KEARNY STREET/COLUMBUS AVENUE PROJECT

Final Supplemental Environmental Impact Report

94.615E
(FEIR State Clearinghouse #86031123)

BUILDING HEIGHTS IN THE PROJECT VICINITY C&R FIGURE 1

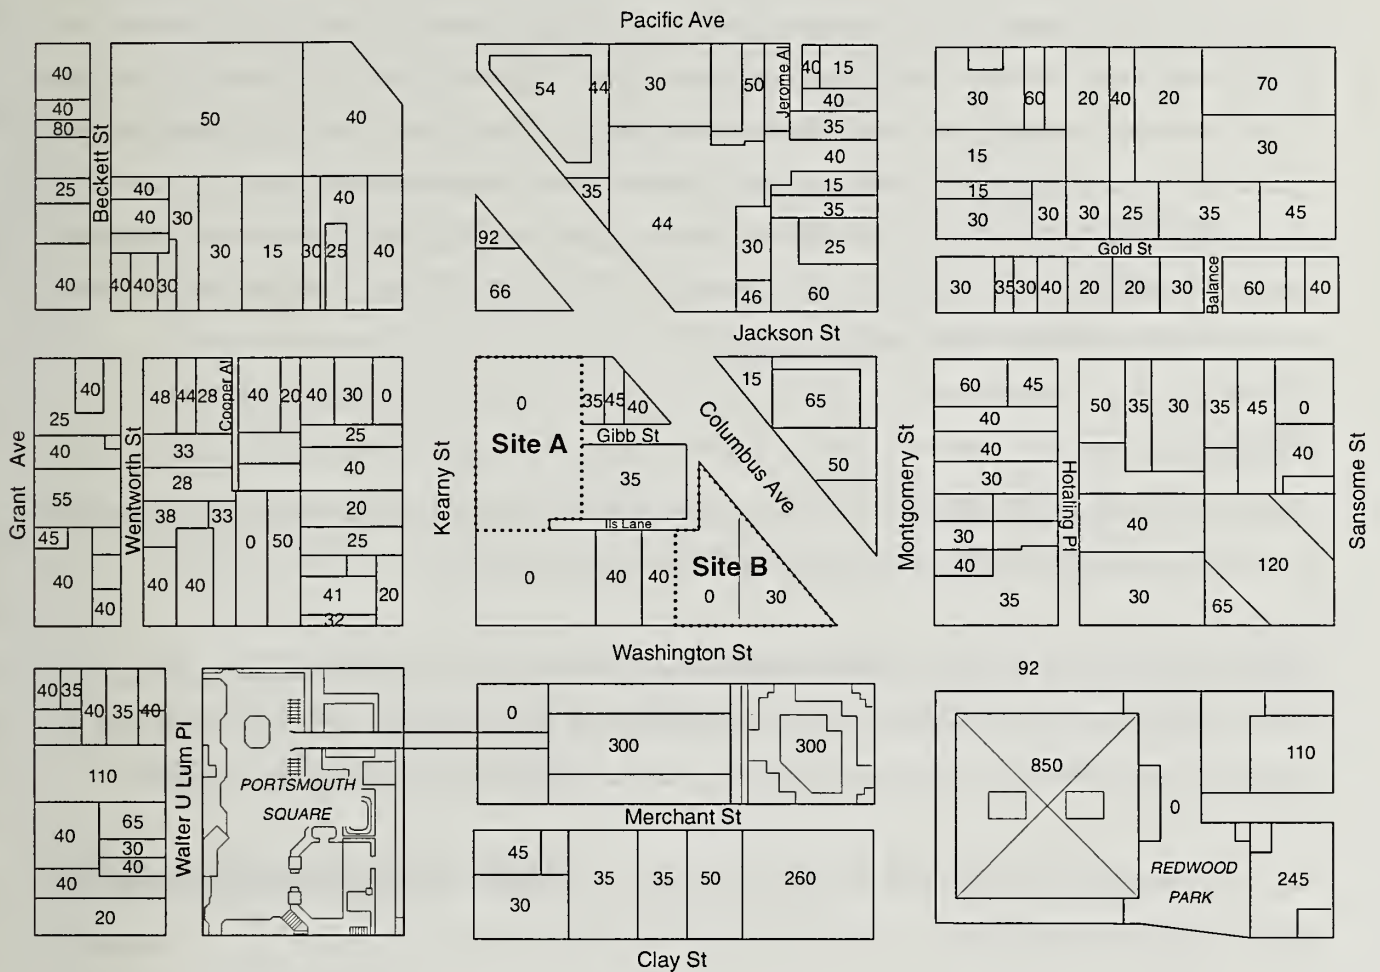
"ENVIRONMENTAL SETTING (page 44): What are the approximate heights of existing buildings in the various areas cited? Inclusion of a map showing these would be helpful here. Page 47 - Please explain: 'While the design of the proposed project was changed, the analysis of the relationship to this policy remains accurate.' How? Why?" (Gee Gee Platt, G. Bland Platt Associates)

On page 49 of the SDEIR, reference is made to Figure 17A, "Building Heights in Project Vicinity" in the 1987 Final EIR (FEIR). This figure has been revised with current building height information (four sites have either new buildings or buildings have been demolished) and is shown as Figure C&R 1 on page C&R.11. The proposed Site A housing building would be about 140 feet in height (excluding elevator penthouse and the trellis) and the St. Mary's Catholic Center would be about 65 feet in height; the proposed Site B building would be about 94 feet in height. The Holiday Inn and the Washington/Montgomery Building on the south side of Washington Street are 300 feet in height. The buildings on the west side of Kearny Street across from project Site A range from 25 to 40 feet in height. The two buildings immediately to the north of project Site A on Jackson Street, 900 Kearny Street and the Columbus Tower Building, are 66 feet and 92 feet in height, respectively. The building heights on the east side of Columbus Avenue, across from project Site B, range in height from 15 feet to 65 feet.

HISTORIC ARCHITECTURAL RESOURCES C&R FIGURE 5

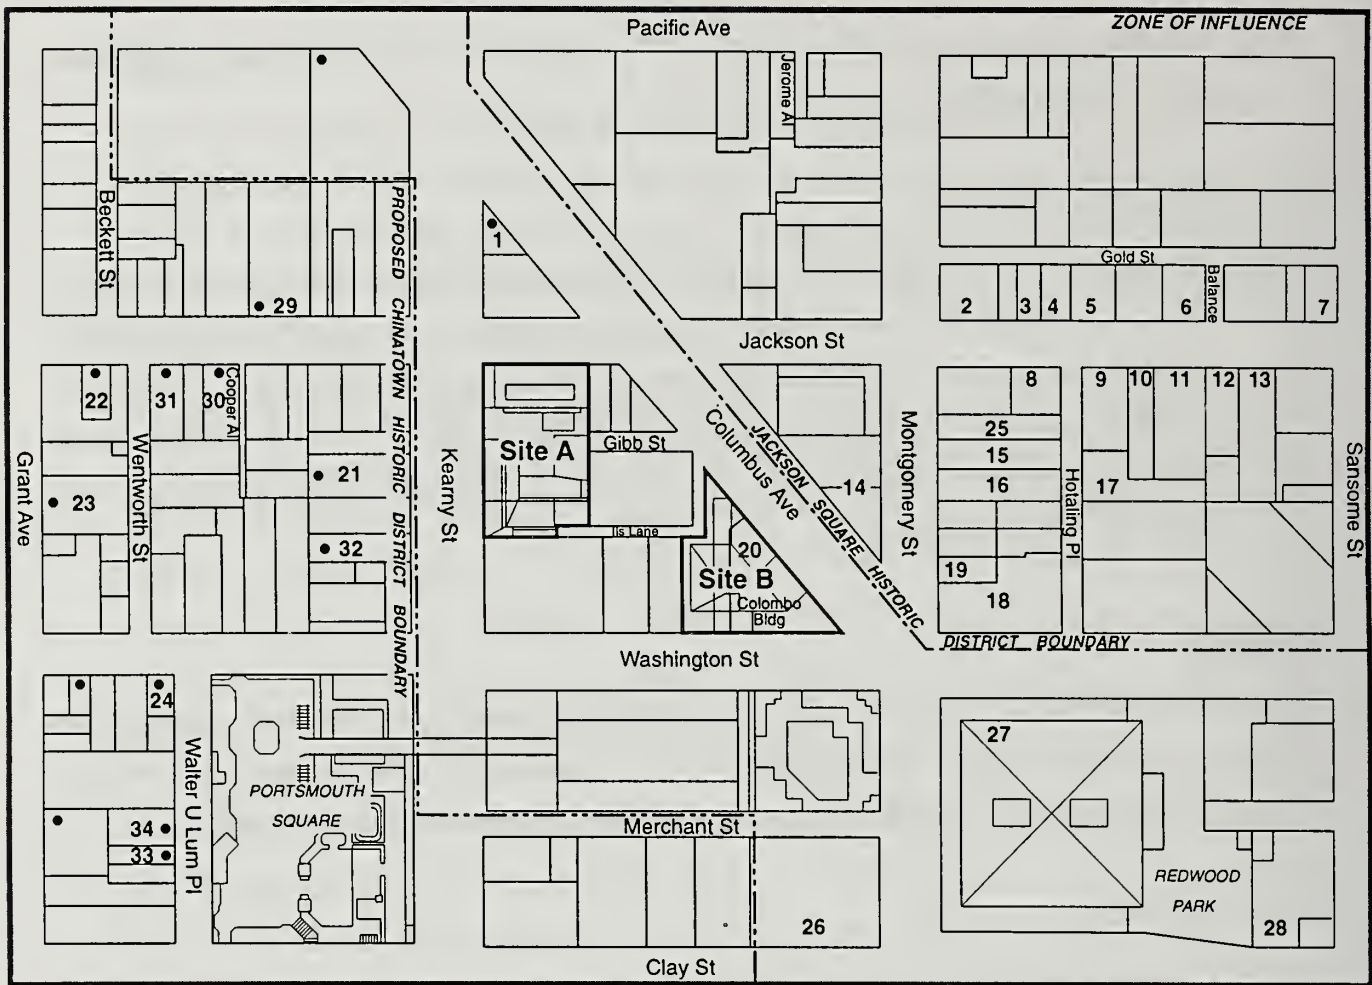
"Figure 1 should differentiate between properties which are city landmarks and those which are architecturally significant; locally we refer to properties in local surveys and Historic Resource Inventories (undesigned) as architecturally significant. This figure does not make mention of properties included in the State Historic Resource Inventory and those identified as contributory

"PAGE AND TURNBULL REPORT. Figure 1 - Please check for completeness, especially in Chinatown. Historic photos - There should be some available of the building and neighborhood. Please include here and in [the] DEIR." (Gee Gee Platt, G. Bland Platt Associates)

Figure 1 in the Page & Turnbull *Kearny Street/Columbus Avenue Historic Resources Study*, has been revised (see Figure C&R 5, page C&R.38) to differentiate between properties in the study area which are City Landmarks and those which are architecturally significant as identified in the 1976 DCP survey. Those buildings that are contributory in the Chinatown Element of the *San Francisco General Plan* are also identified in Figure C&R 5.

As noted in the above response, Figure 1 has been revised to show which buildings are City landmarks and those which are architecturally significant. Research of the archives failed to obtain any historic photos of the Colombo Building. Two publications reviewed by the historic architecture consultants contain excellent collections of historic photographs of San Francisco's Chinatown: *Photographs of San Francisco's Old Chinatown*, by Arnold Genther, New York, Dover Publications, 1984; and *Bridging the Pacific: San Francisco Chinatown and Its People*, by the San Francisco Chinese Historical Society of America, 1989. Due to the time constraints required to obtain the publishers' permission, selected photos are not included in this report.

LOCATION OF SITE PHOTOS AND PHOTOMONTAGES C&R FIGURE 6

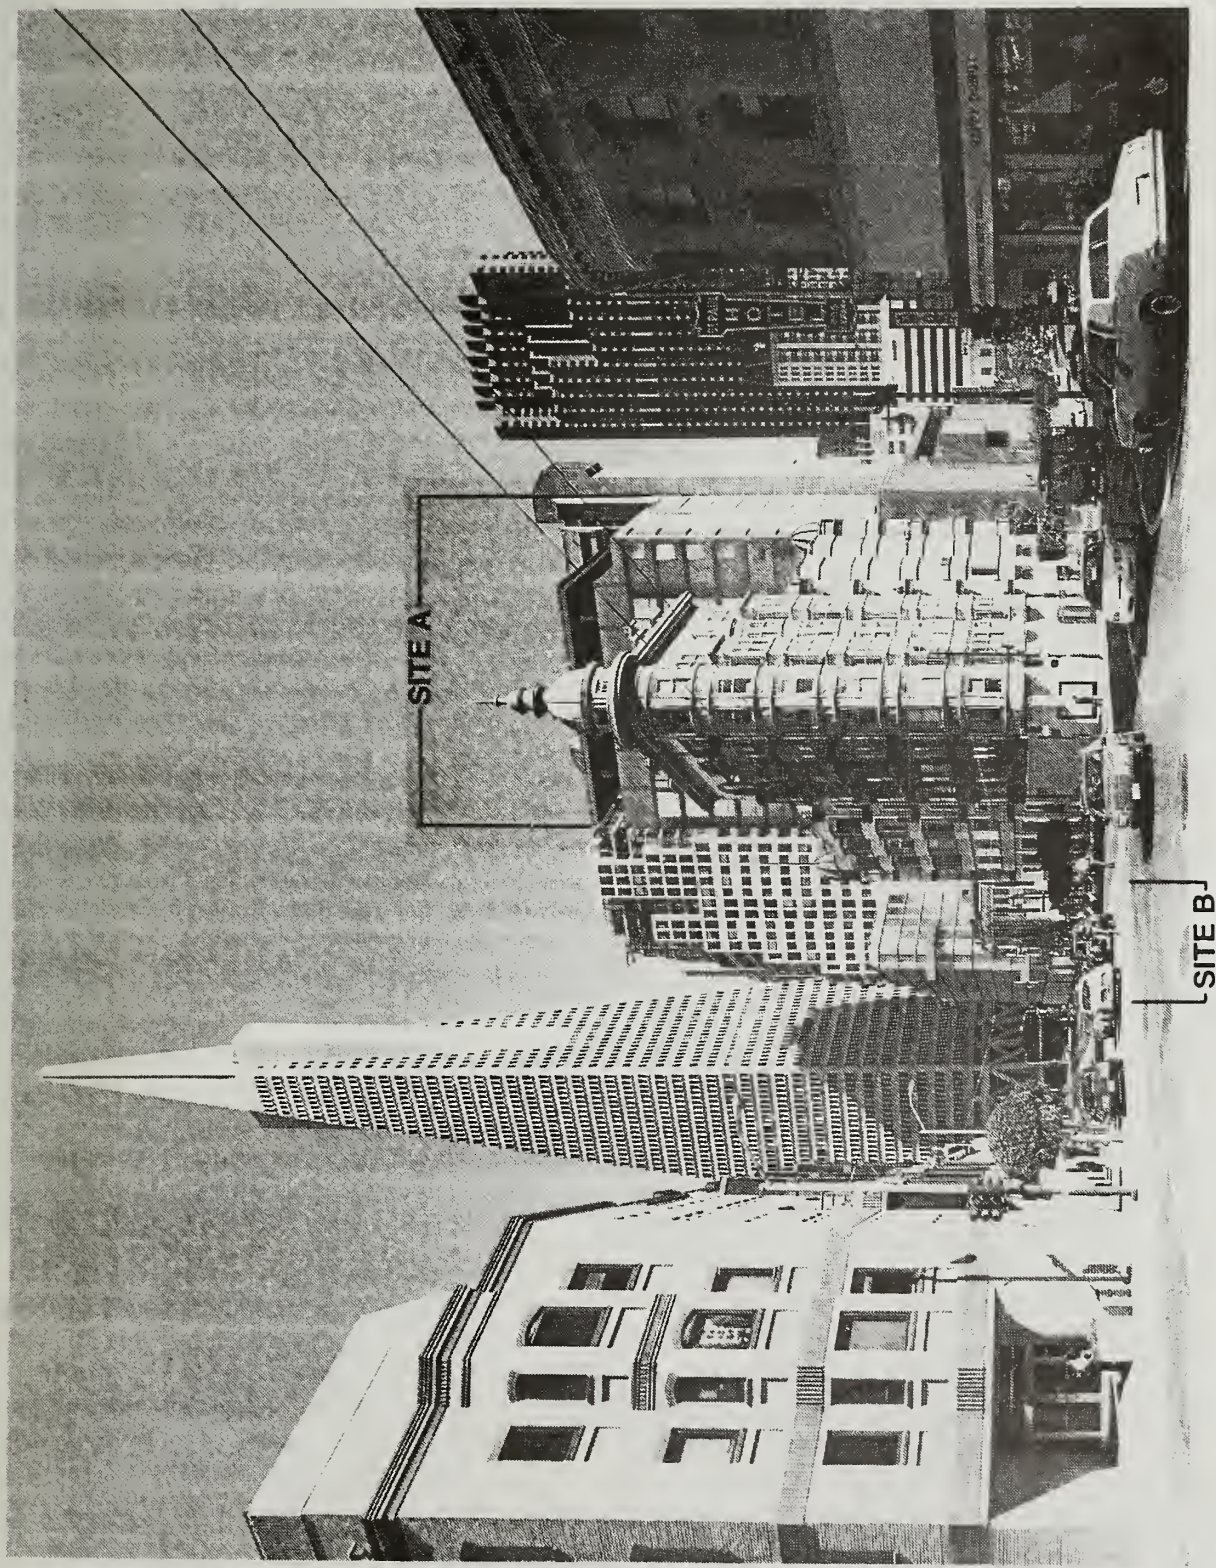
"Using a map, such as Figure 1 on page 23, to show position of photographer and direction of photograph would be helpful.

Figure C&R 6, Location of Photos and Photomontages, is found on page C&R.68. It shows the location of where the photographs were taken and the direction of view. In addition, the photomontages in the SDEIR (Figures 18, 19, 20 and 21, pages 68 to 71) have been revised to identify the proposed project buildings on Site A and Site B, and are found on pages C&R.69 through C&R.72.

PROJECT SHADOW PATTERNS—MARCH 21 FIGURE 22 (REVISED)

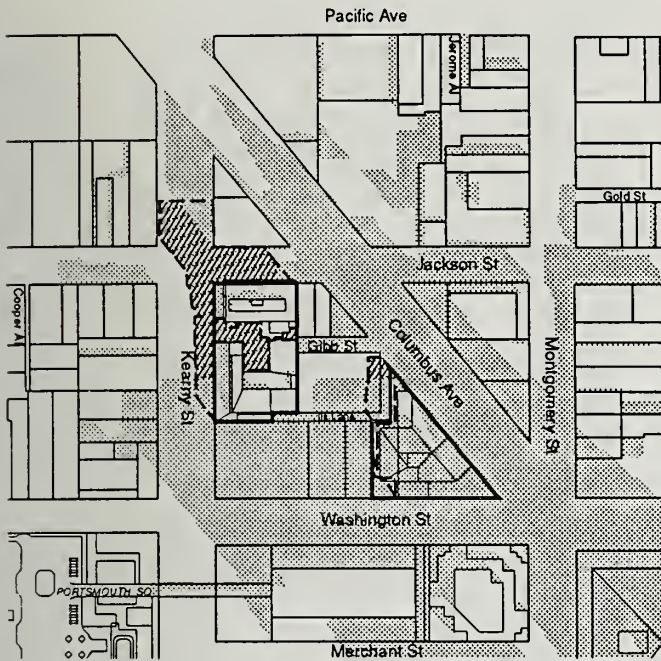
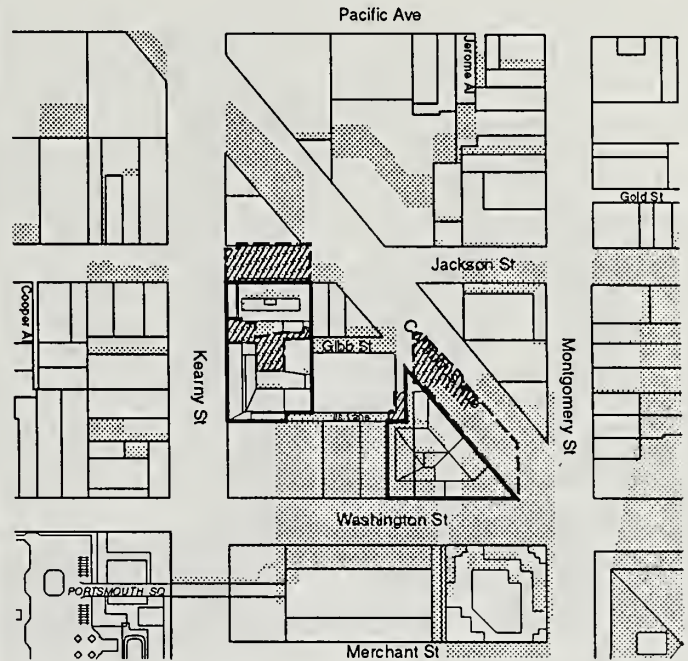
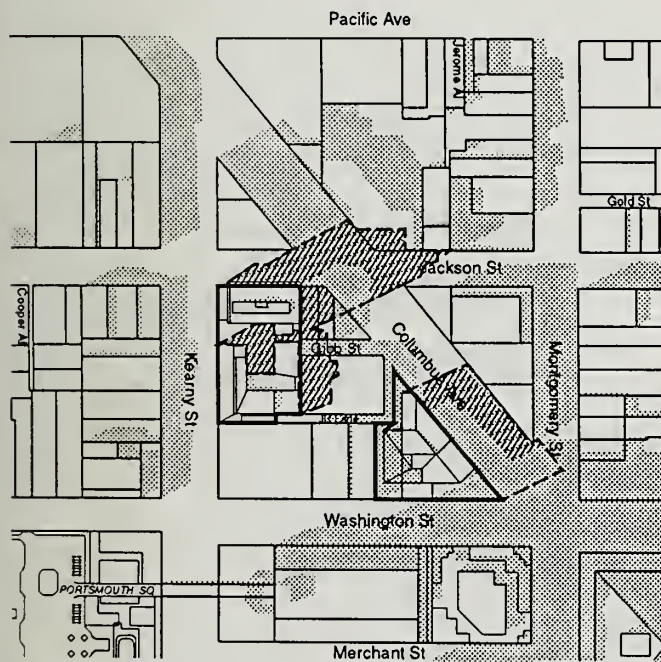
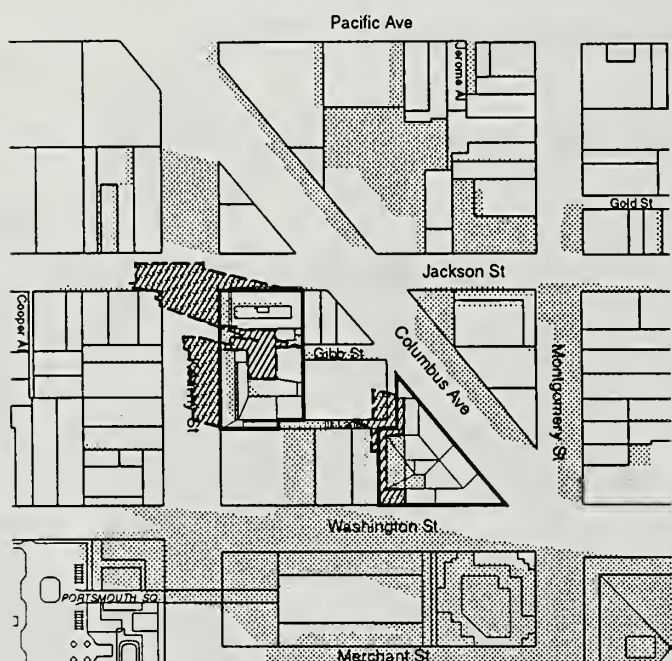
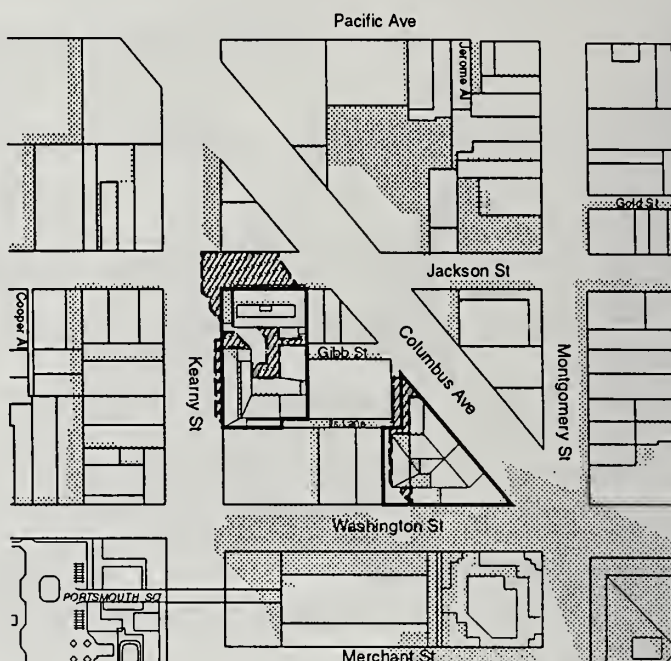
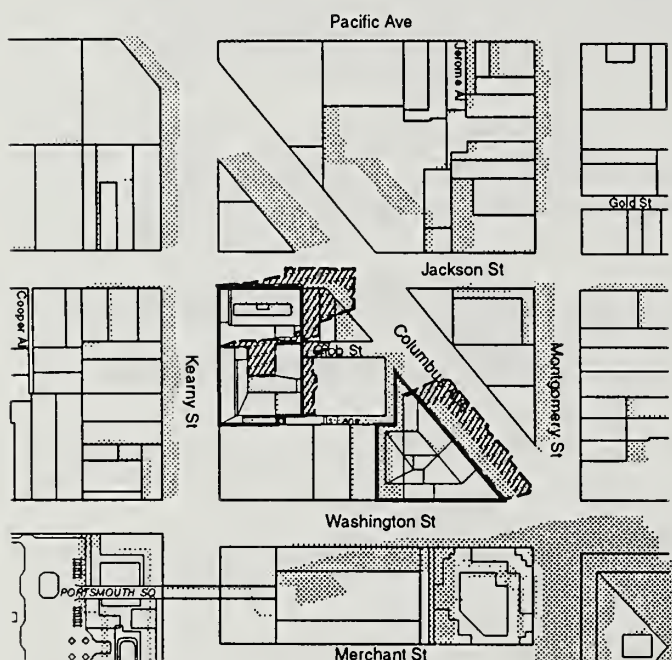
The project shadow patterns shown in Figures 22, 23, 24 and 25 in the SDEIR (pages 72 and 74 to 76) have been slightly revised and are shown in the Errata chapter on pages C&R.75 to C&R.78. The two retail/restaurant establishments adjacent to the project site (on Jackson Street) would be in shadows cast either by the buildings in which they are located or by other non-project buildings at 12:00 noon on March 21, September 21 or December 21. There would be no shadows in front of the retail/restaurant spaces at 12:00 noon June 21. There are two restaurants with outdoor seating on Columbus Avenue, near the project: Sophies (formerly, Clown Alley) and Macaroni. The project would not cast new shadows on either of these two locations at the times studied in the shadow diagrams (one minor exception is on December 21 at 3:00 p.m., the project would cast a shadow at the northwest corner of the Sophies lot). The project would cast

Page 72, 74, 75 and 76, replace the Figures 22, 23, 24, and 25 follow this page on pages C&R.75 through C&R.78.
